User Safety Notice

30 ft. / 9 m. Workman® Self-Retracting Lanyard

October 28, 2015

Yellow Tamper Evident Paint

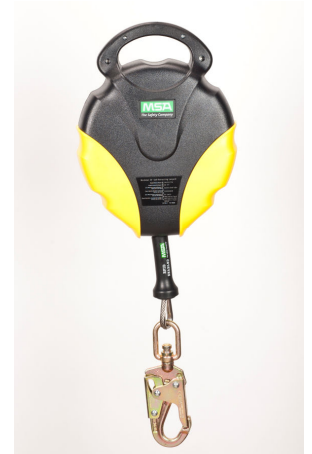
We have determined that a small percentage of Workman 30 ft. / 9 m. SRLs manufactured from January through August of 2015 may have an improper brake nut torque setting. This condition is not detectable when performing the normal pre-use inspection procedure. SRLs with this condition may not arrest a user's fall or may not arrest it within the specified maximum arrest distance.

Please note that the replacement SRLs may also have a "date made" from 01-2015 through 08-2015, but include yellow tamper evident paint on the exterior housing screw heads near the handle, as shown in the photo below. These SRLs are new units that were factory upgraded to include a new brake assembly and are acceptable for use.

It is important that you immediately mark all affected SRLs "UNUSABLE" and then discard or return them to MSA, unless they pass the special inspection. SRLs that pass the special inspection may be used until April 30, 2016, but then must be marked "UNUSABLE" and discarded or returned to MSA. Please cut the cable on any SRLs that are discarded to ensure that they cannot be used.
